Product Change Notification

1. ECN #: 272753

- HDMR - HDMR FLANGED SURFACE MOUNT SOCKET

- HDMR-19-XX-X-SM-XX-XX

1. Structure comparison

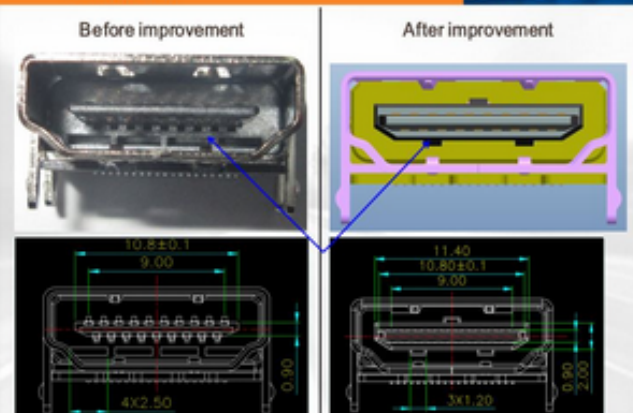
Change assembly method from manual assembly to insert molding process.

Insert molding process assemblies have minor visual difference compared to the manually assembled product. Remove protrusions on shield;

3. Right view

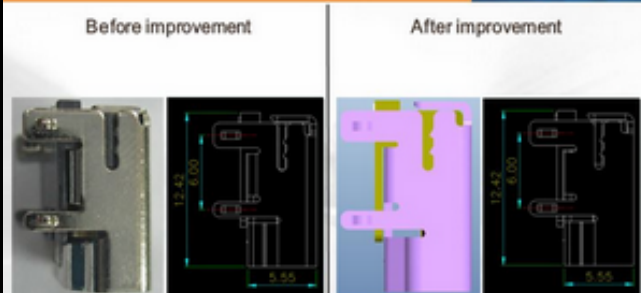
Without difference
